PLANT NAME: Nine Mile Point #1

NIAGARA MOHAWK POWER CORPORATION

Re: Nine Mile Point Unit 1
Docket No. 50-220

Pursuant to Section 50.59 of the Commission's Regulations, Niagara Mohawk plans to make a change in its facility under Provisional Operating License No. DPR-17. Briefly, this change consists of installation of plugs in the upper end of the non-instrumented incore housings.

IN-CORE HSS Plug
Layout

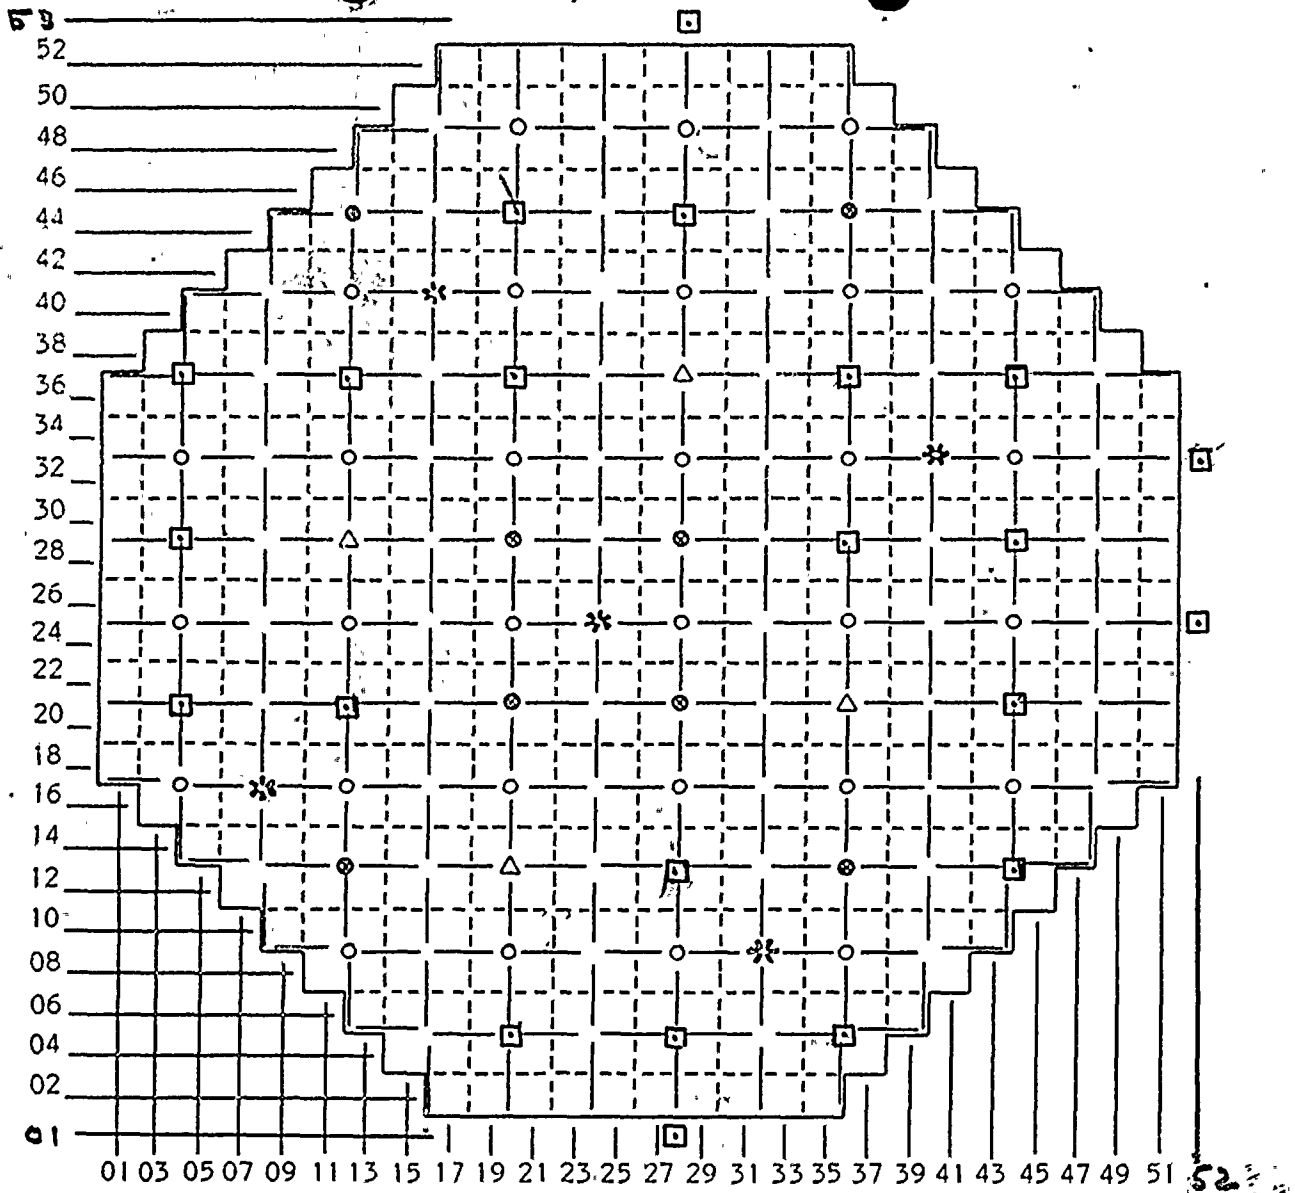
The modification is designed to prevent the accumulation of radioactive scale in the non-instrumented incore housing flanges under the reactor vessel. The scale accumulation in these housings produces high radiation levels under the vessel and interferes with control rod drive maintenance operations.

The proposed facility modification provides for installation of plugs in the upper end of the non-instrumented incore housing as shown in Figure 1 attached. This will prevent the accumulation of radioactive scale in these incore housings. The four fuel assemblies surrounding the incore housing would be removed and the plug inserted. As can be noted from the attached figure, a fluid path is provided through a screen into the core housing from the area between the upper and lower core support plates. This will prevent any pressurization force buildup within the incore housing by providing equalized pressures in and out of the tube. The plug assembly cannot be forced completely out of the incore housing due to the normal positioning of the fuel assemblies and the length of the plug assemblies. The twenty-two spare incore housing locations are shown on Figure 2.
